Project #: 14961.06 / 15592.67

Re: Sturbridge Route 20 Drainage Repair Project  
Response to MassDEP Comments  
DEP File No. 300-1175

The purpose of this memorandum is to provide responses to the Massachusetts Department of Environment Protection (MassDEP) comments on the Notice of Intent (NOI) submitted for the Sturbridge Route 20 Drainage Repair Project (DEP File # 300-1175).

PLANTING PLAN

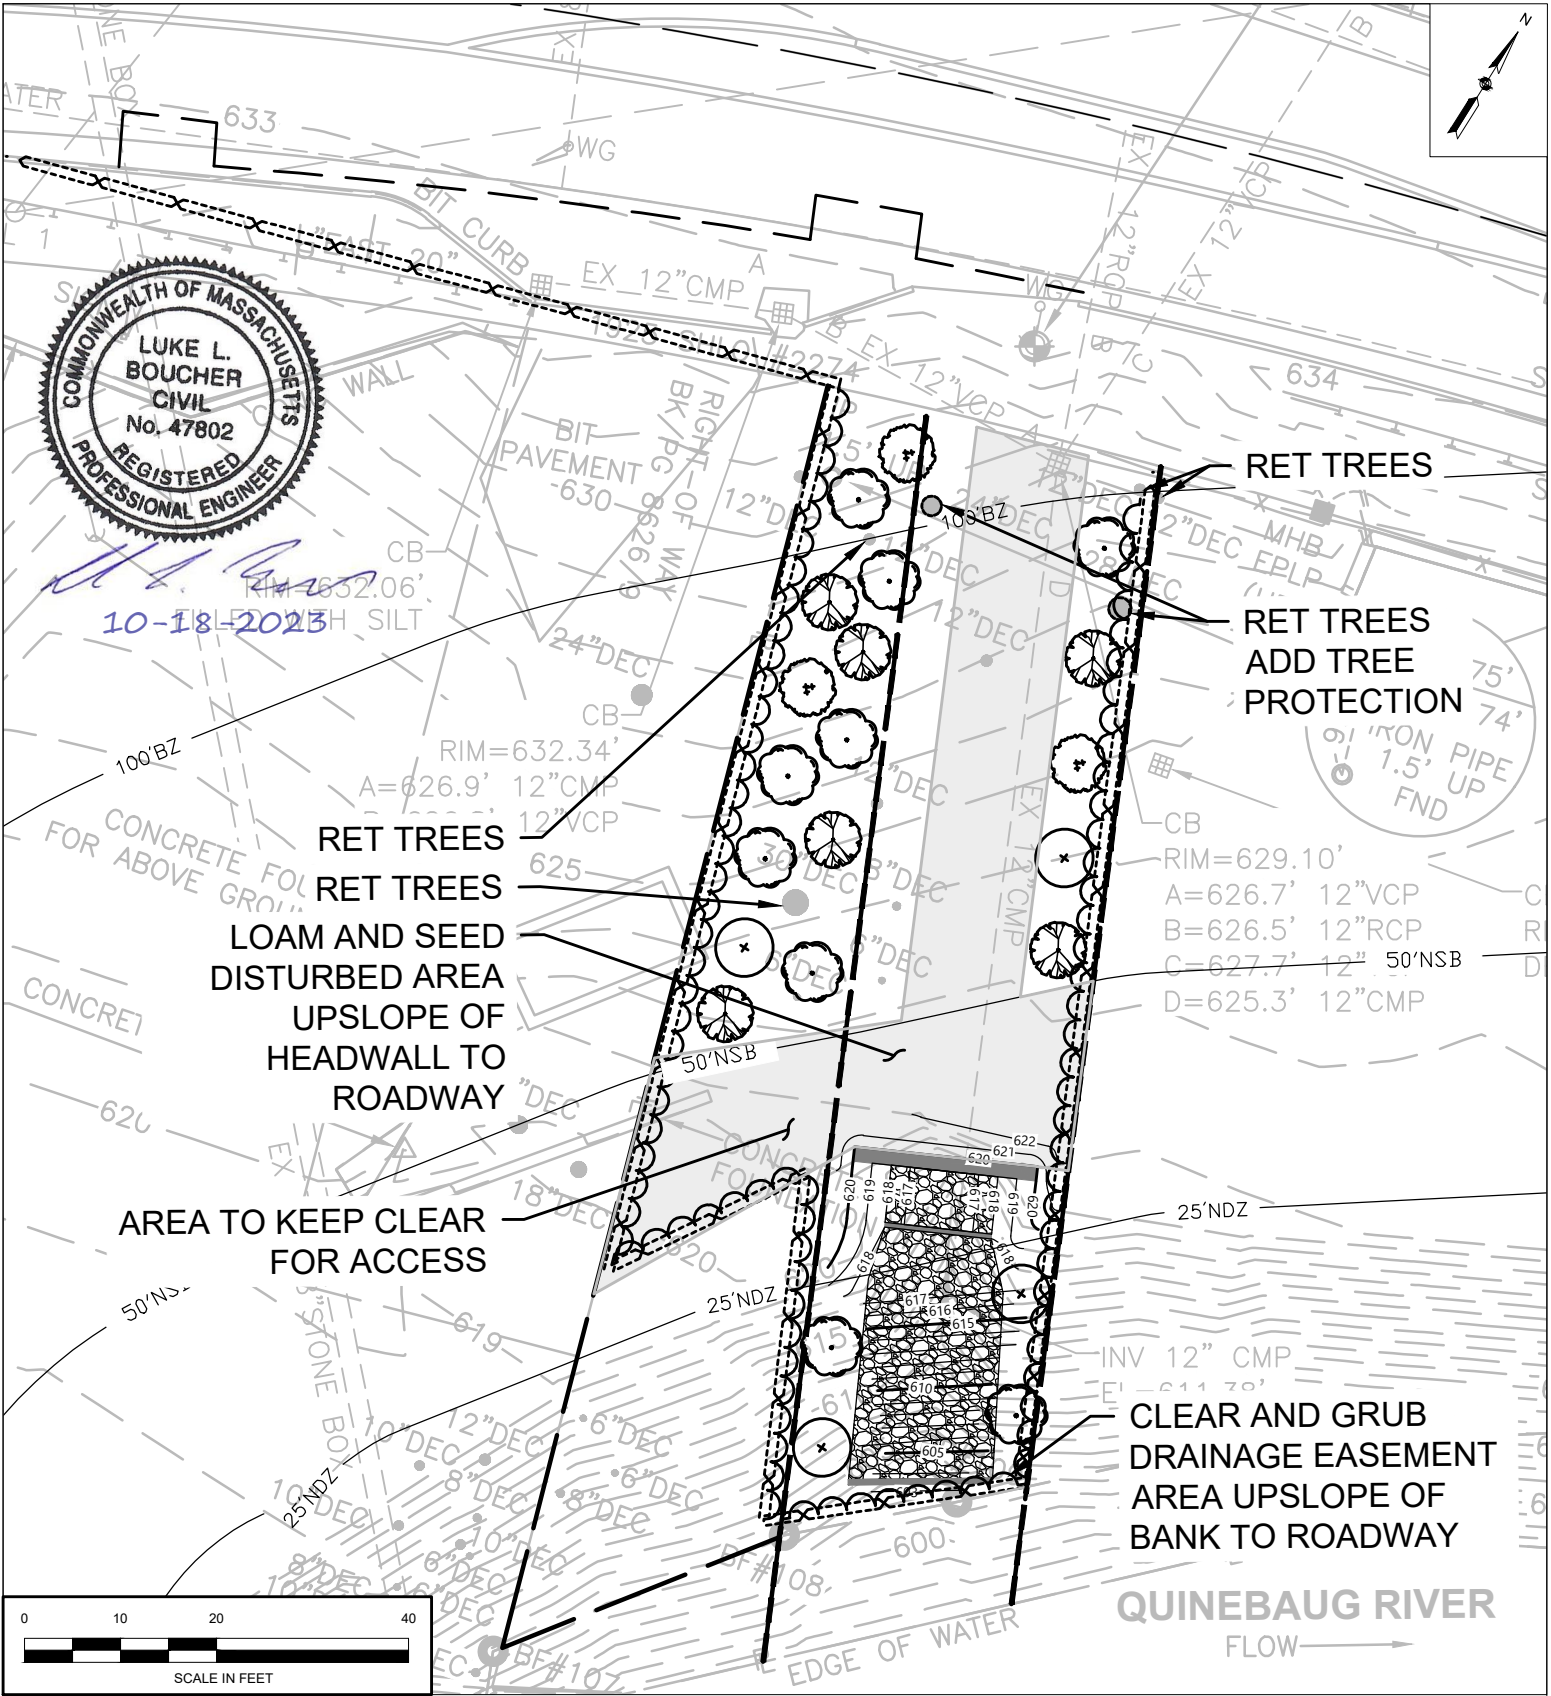
- **This option was deemed not viable.**
2. As the Riverfront Area being altered is forested, native tree and shrub plantings following construction should be considered where practicable throughout the limit of disturbance to comply with 310 CMR 10.58(4)(d)1.a. notwithstanding the allowance for SCMs as previously noted.

**VHB Response: See the attached planset, which has been revised to include proposed plantings in this area.**

# STONE SLOPE PROTECTION

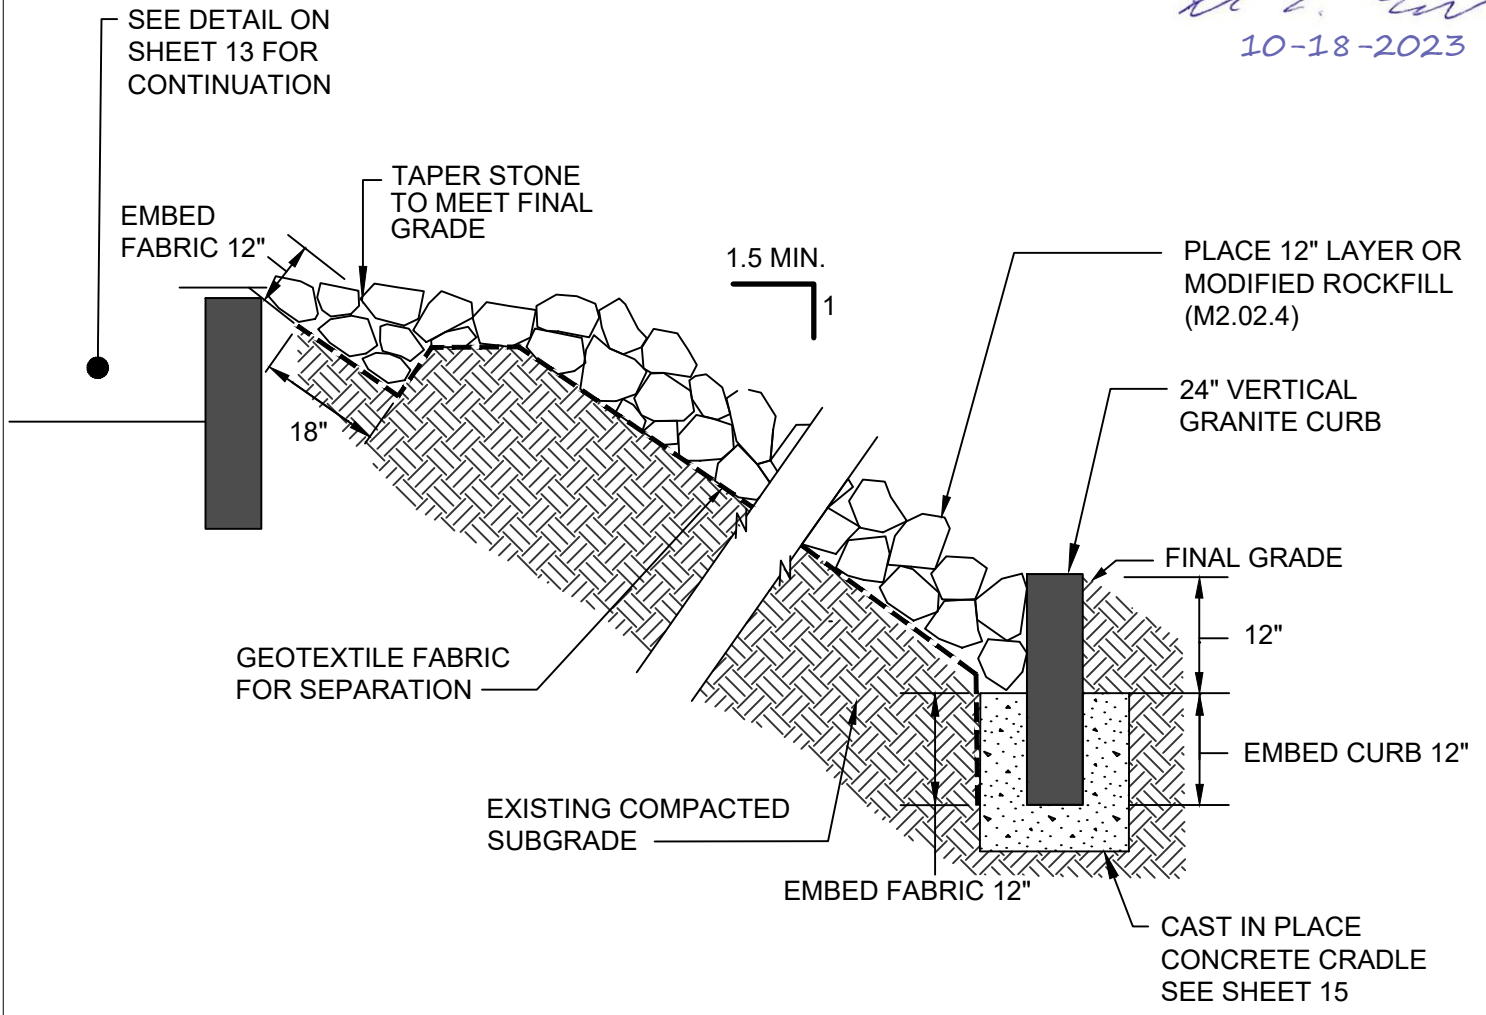
3. Placement of loam and plantings such as live willow stakes should be considered within the proposed modified rock fill for the stone slope protection.

**VHB Response: As this is a riprap spillway that will be receiving discharged stormwater, not just a riprap stabilized slope, we would not recommend placing loam in the modified rock fill, as the loam would be susceptible to washout into the river. The steepness of the proposed slope precludes the velocities from being low enough to prevent erosion.**

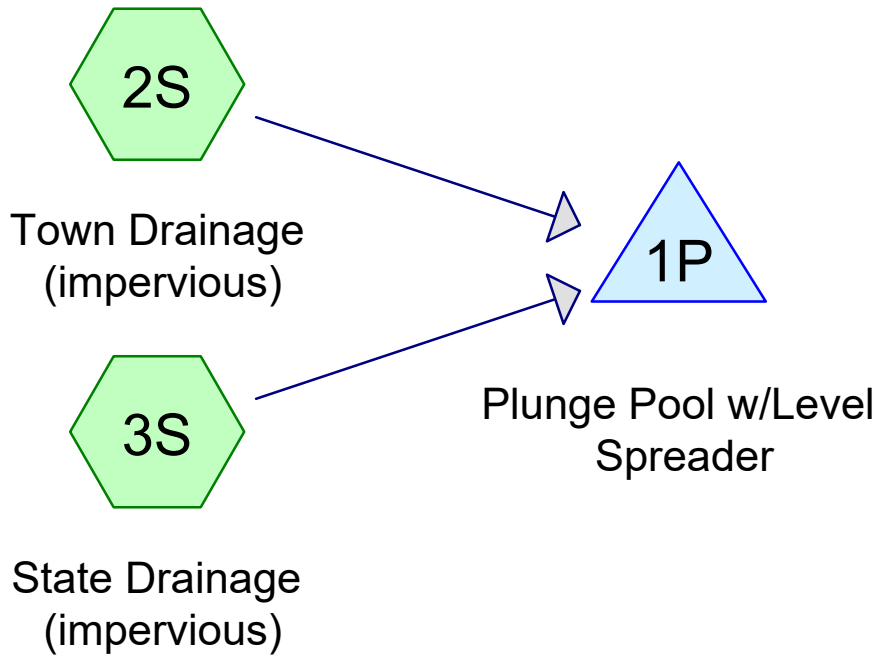
5. Sizing calculations should be provided for the proposed level spreader.

***VHB Response: See attached level spreader calculations, which indicate that the flow depth will be approximately 4 inches for the 10-year design storm. Please note that the purpose of the level spreader design guidance included in the MassDEP Stormwater Handbook is to reduce velocities, thereby minimizing soil erosion on relatively flat (<6%) downgradient vegetated areas. As the proposed slope downgradient of the level spreader is proposed with a steep riprap surface, prevention of soil erosion is not the purpose of the level spreader. The proposed level spreader is only intended to evenly distribute flows to the riprap slope.***
